WORKSHOP AGENDA

Planning Commission

October 14, 2025 @ 5:30 PM

Item #: 3. Site Plan - Dous Retail Center - Building totaling 4,200 Square Feet on 1.28 Acres. Requested by Chet Rhodes. Property located at 5130 Murfreesboro Road (Tax Map 15M, Group A, Parcel 1). C-2 (Highway Service) Zoning District. Property owned by TN Group Properties, LLC.

SHEET NO. C6.02

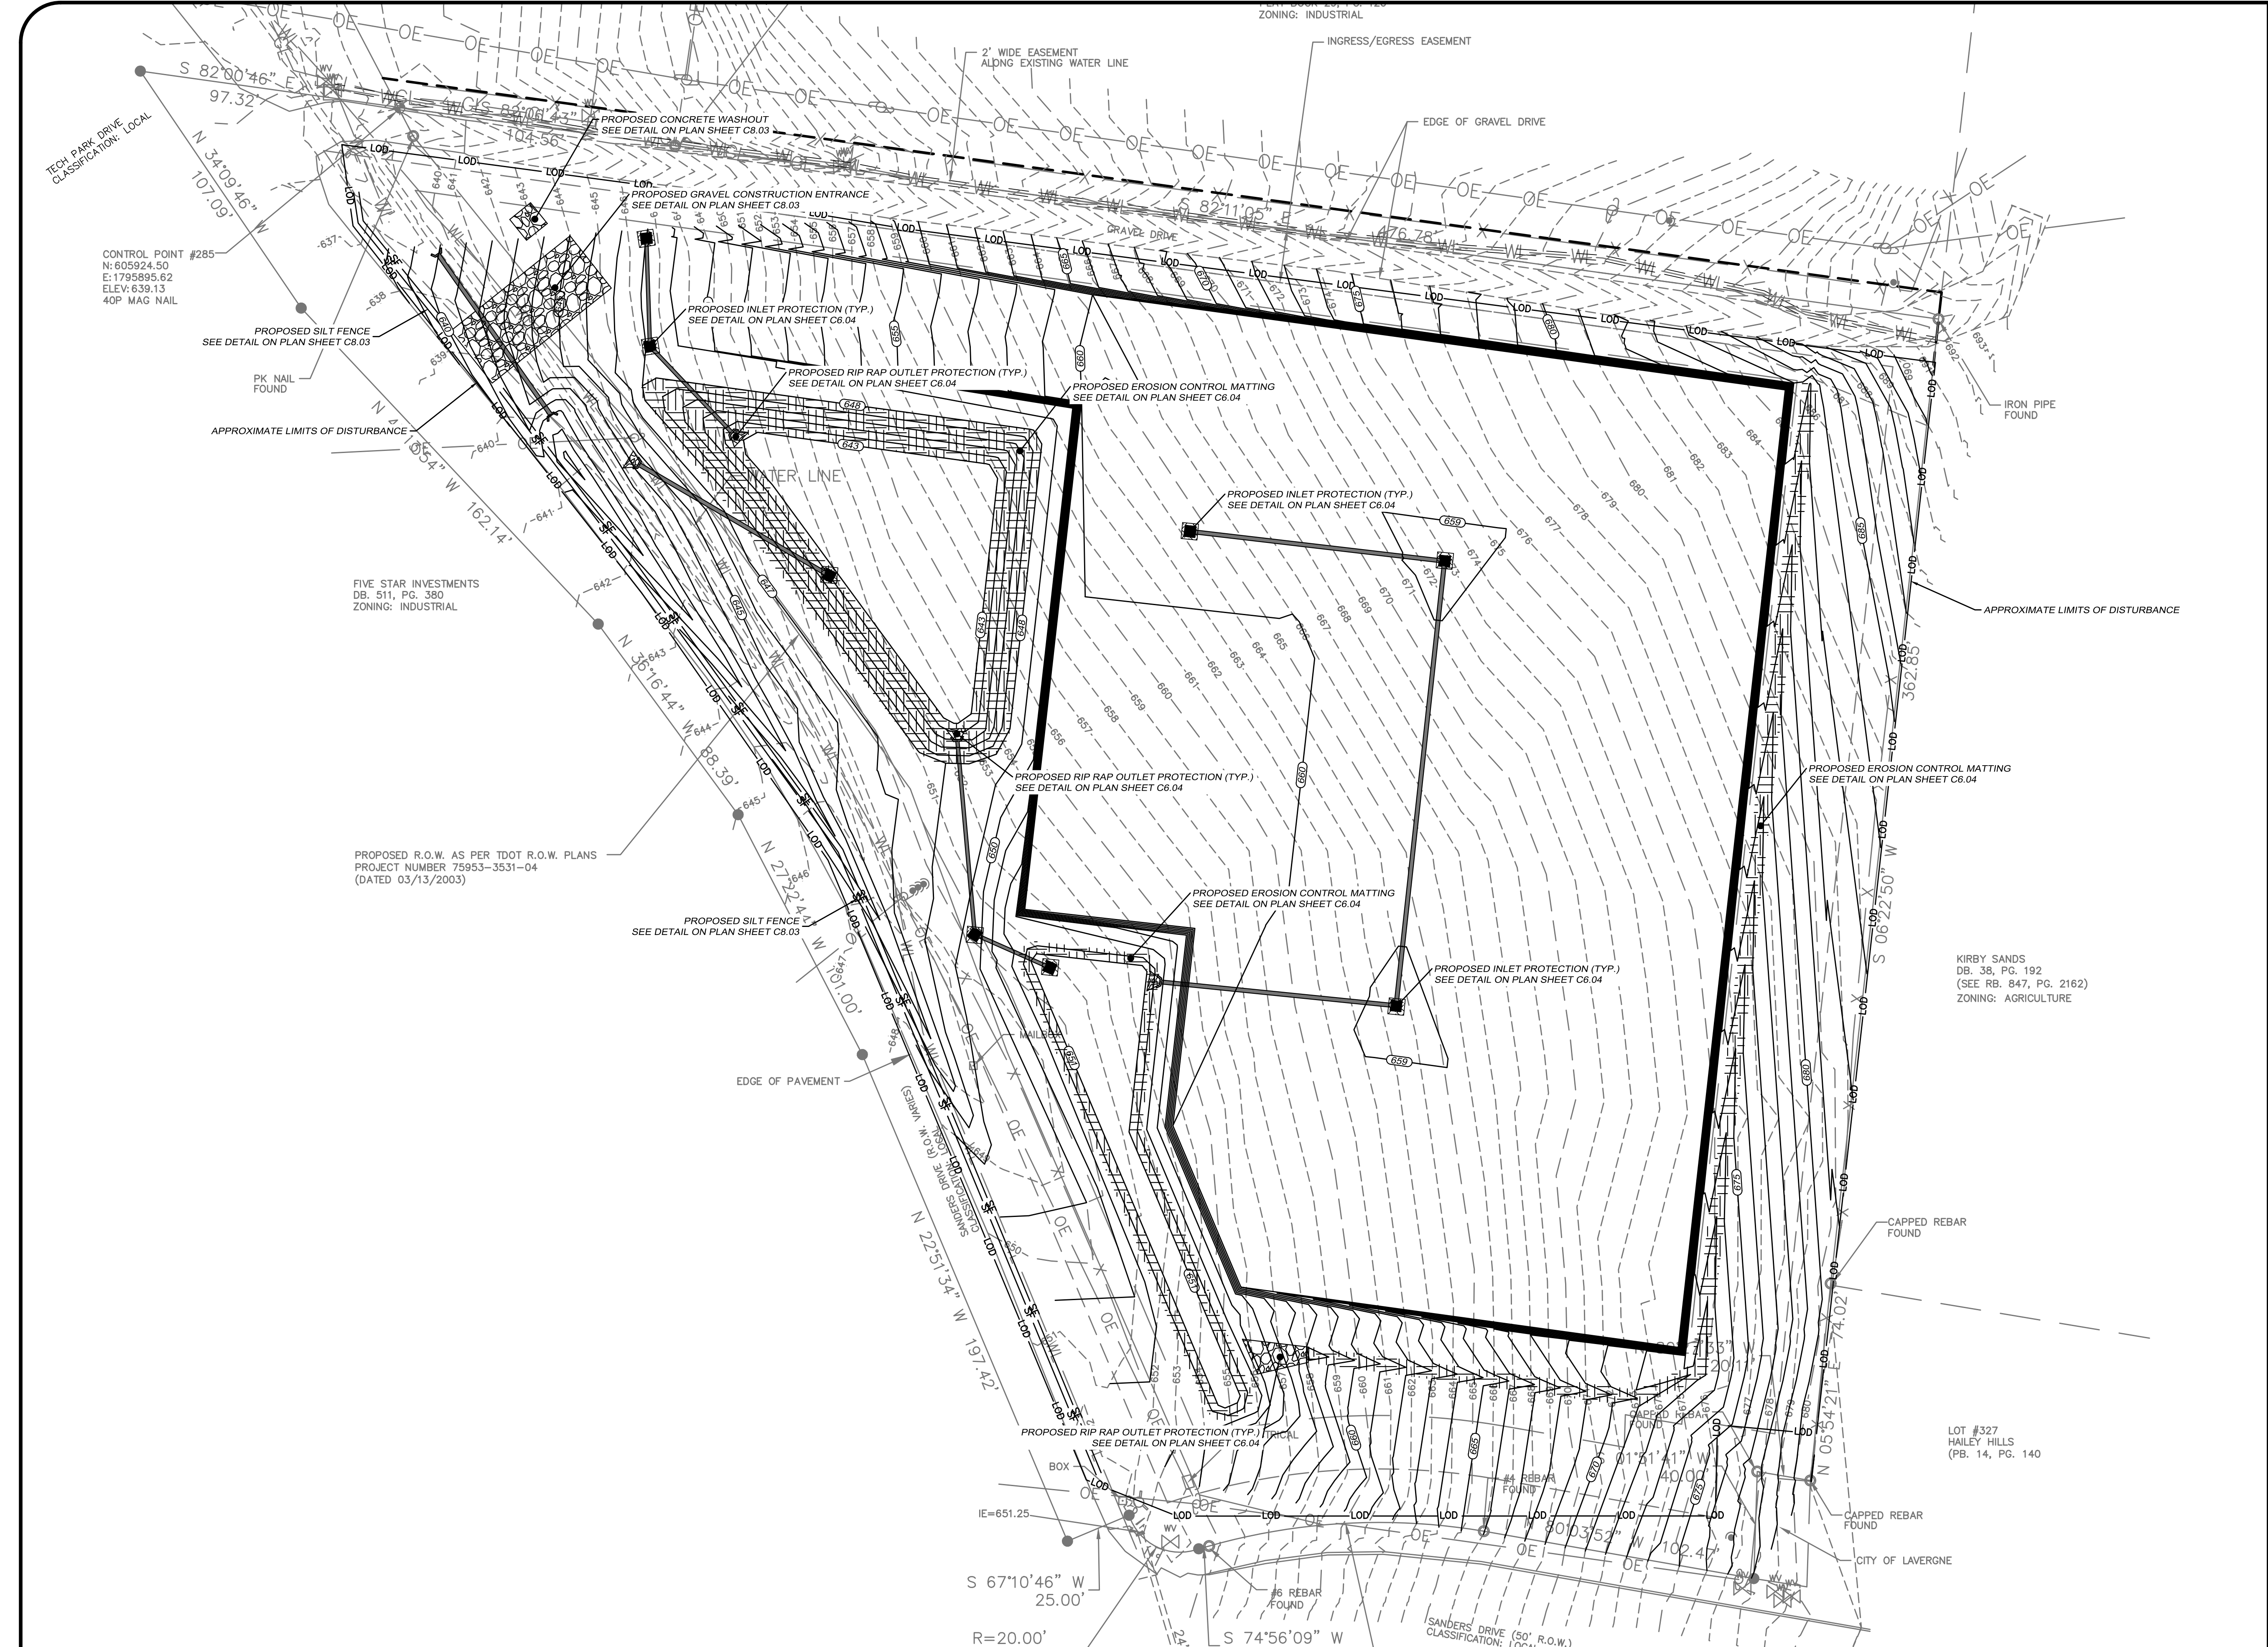
30. (Sheet C6.01, C6.02) Correct Silt Fence, Concrete Wash-out, and Construction Entrance references (the sheet reference is incorrect)
31. (Sheet C6.01) Show construction entrance graphically at 100 feet long.

37. (Sheet C6.02) Notes are labeled as "Initial" notes. Change to "Intermediate" notes
38. (Sheet C6.02) Add a note that sediment ponds will be excavated and functional and run-off water diverted into them before topsoil stripping can begin on the main parking lot. It is understood that some grading will be required within the pad area to construct the sediment ponds.

39. (Sheet C6.02) This plan needs to show the grading necessary for the sediment ponds to comply with Item 38 above.
40. (Sheet C6.01) Show inlet protection at the existing culvert under the existing access drive along the north boundary.

PROJECT NO. 1574-01	
SEPTEMBER DATE: 2025	DRAWN BY: HLP
	CHECKED BY: RWM
SCALE: 1"=30'	APPROVED BY: RWM
SHEET NO. C6.03

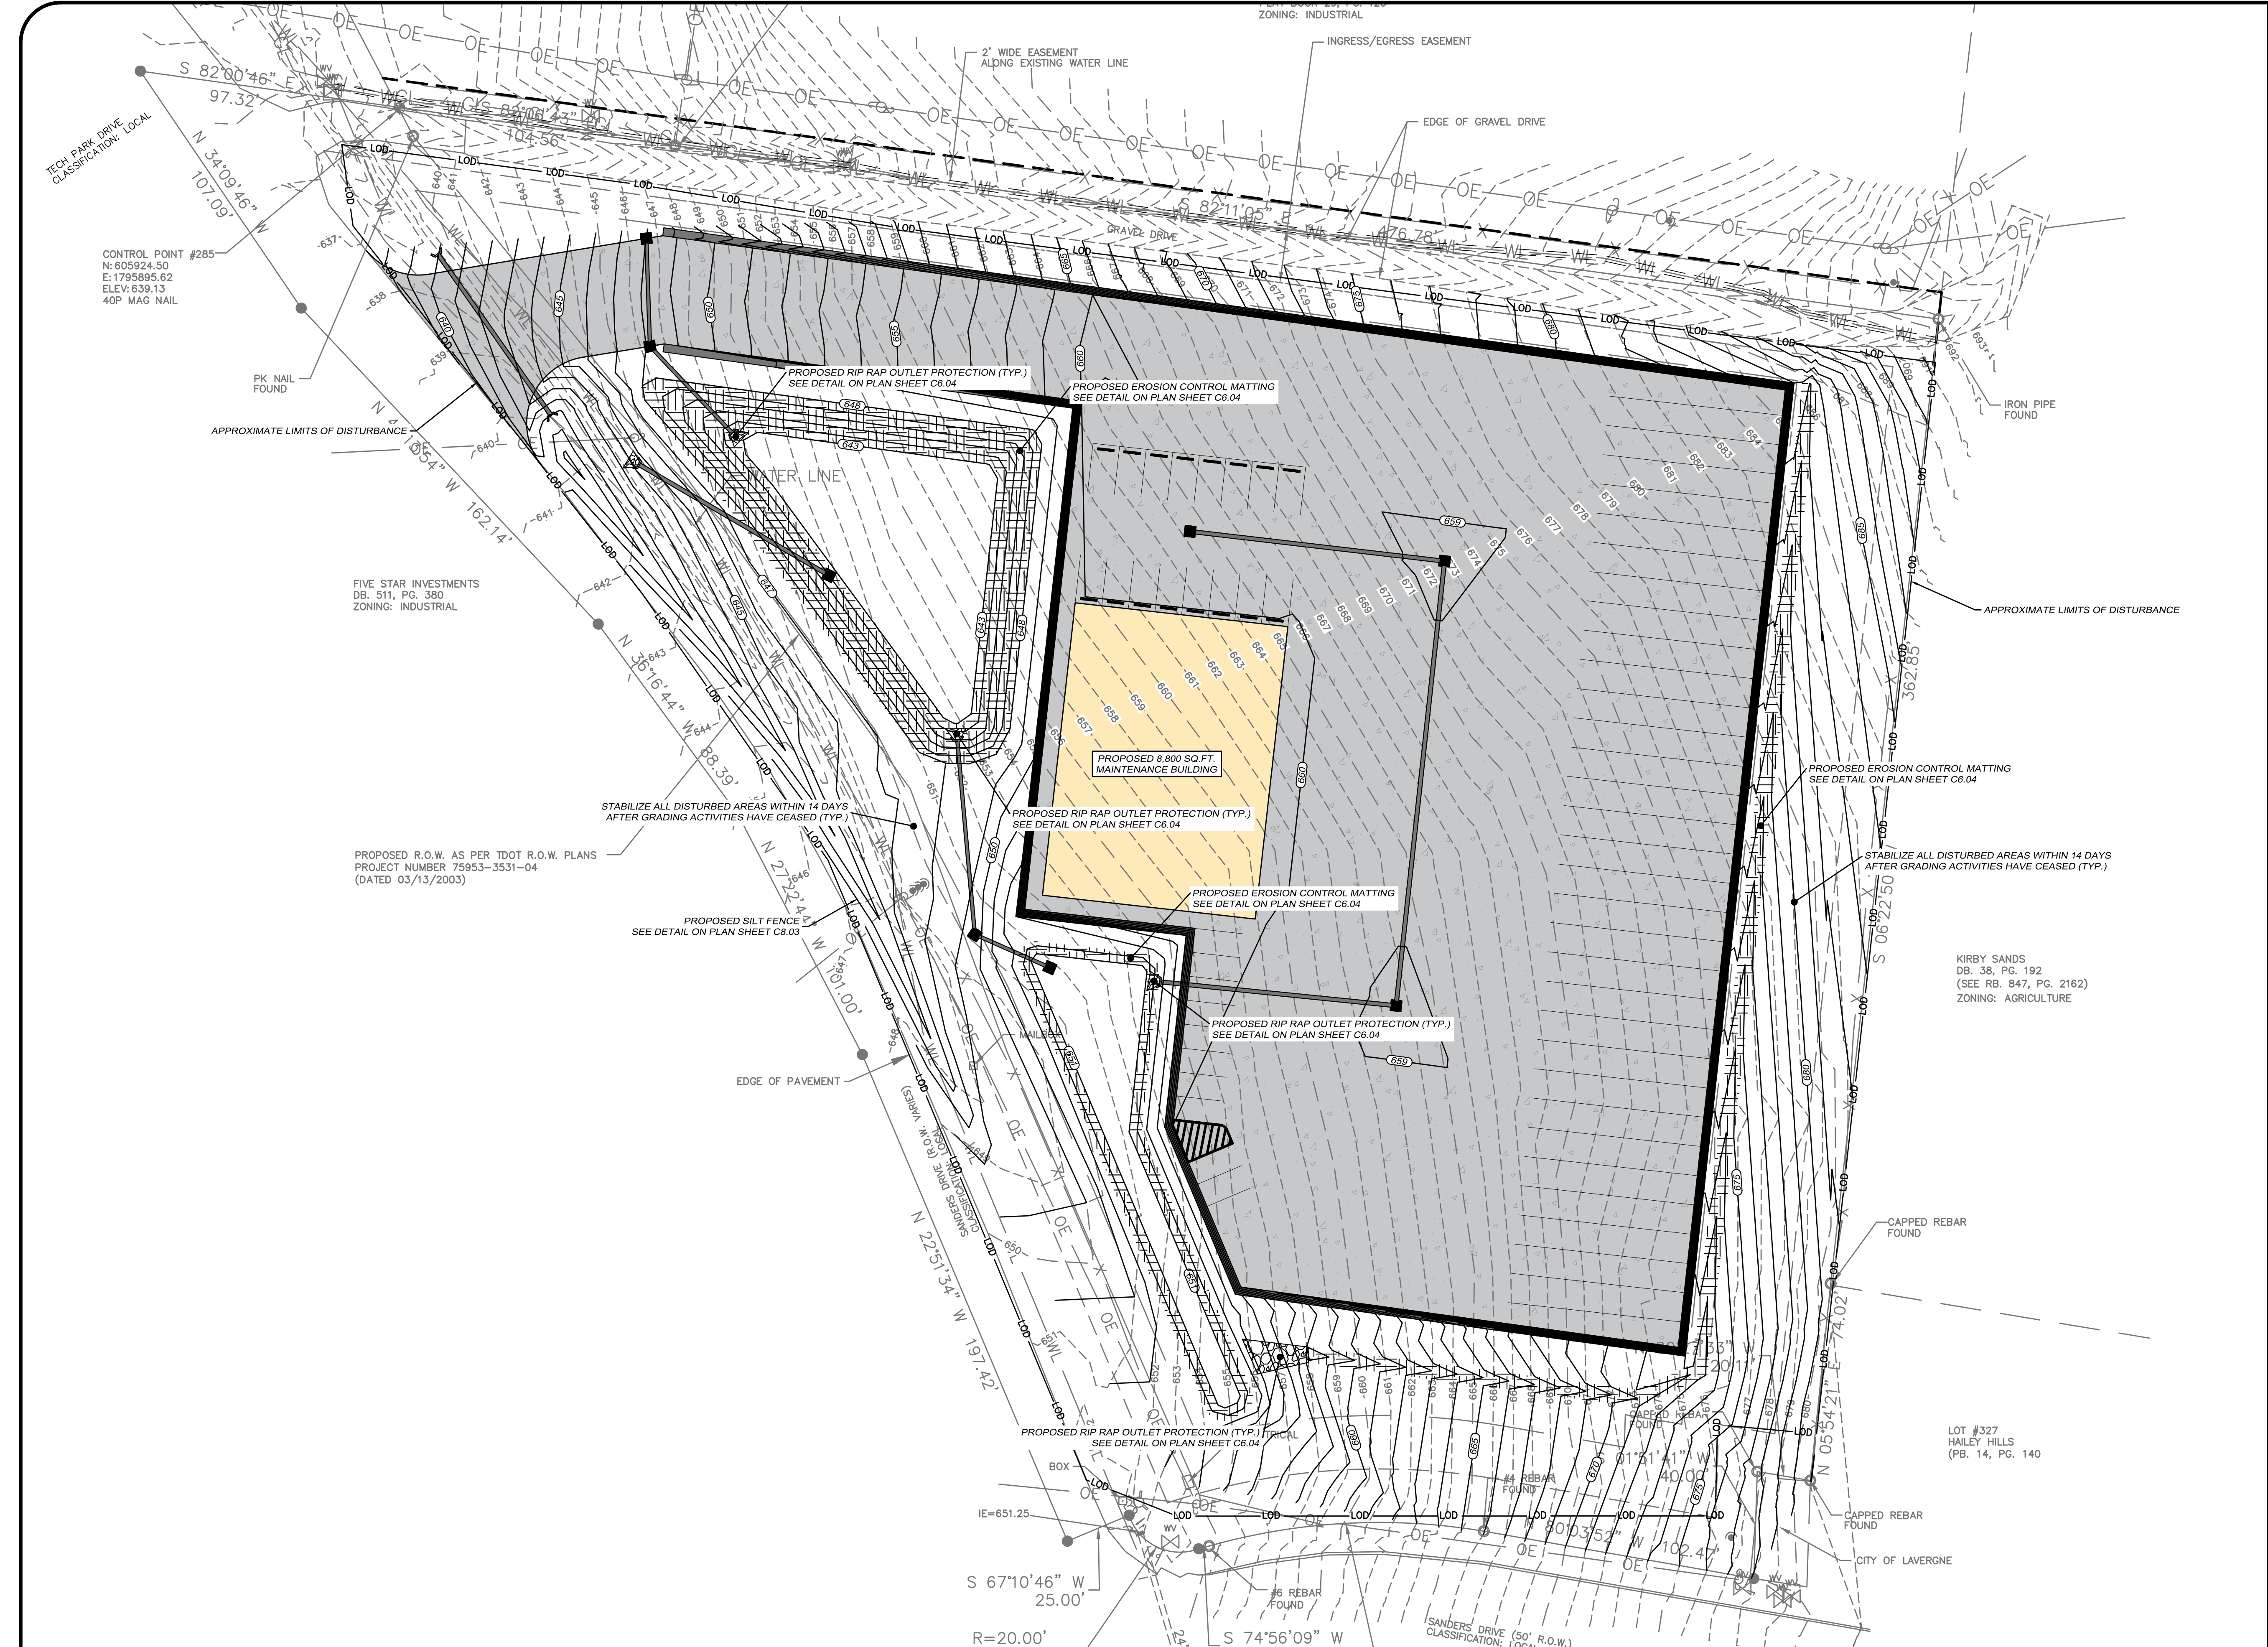
21. (Sheet C4.01) Provide erosion protection from the outfall of Storm Line D down to the flowline of Ditch A.
22. (Sheet C6.03) Provide a note that all EPSC controls shown on this sheet are permanent.

41. (Sheet C6.03) Change notes to "Final" notes.
42. (Sheet C6.04) Provide as detail for riprap outlet protection which includes geotextile, D50, of riprap installation, and minimum area.
